GM CUSTOMER CARE AND AFTERSALES  
DCS3185  
URGENT - DISTRIBUTE IMMEDIATELY

Subject: 14113 - Safety Recall  
Replace Ignition Lock Cylinder and Ignition Key

# Recall Bulletin

**SUBJECT:** Replace Ignition Lock Cylinder and Ignition Key

## PART INFORMATION

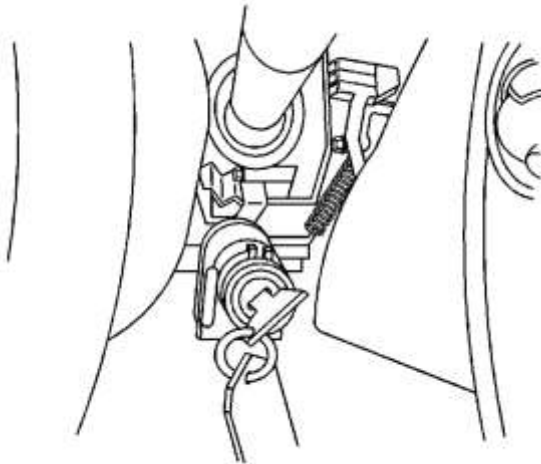
**Note:** GMCCA will utilize the VIN number provided on the ignition switch SPAC order to place an order on your behalf for the parts required for this recall as well as to complete safety recall 13454 or 14063, whichever is applicable. This will ensure alignment of the ignition switch shipment with the parts needed to complete all required recalls. You may receive the parts required for the repair as kit number 23232575 (Chevrolet branded keys) or kit number 23232576 (unbranded keys for Saturn or Pontiac vehicles). Each kit will contain an ignition switch, an ignition lock cylinder, two keys and two key rings.
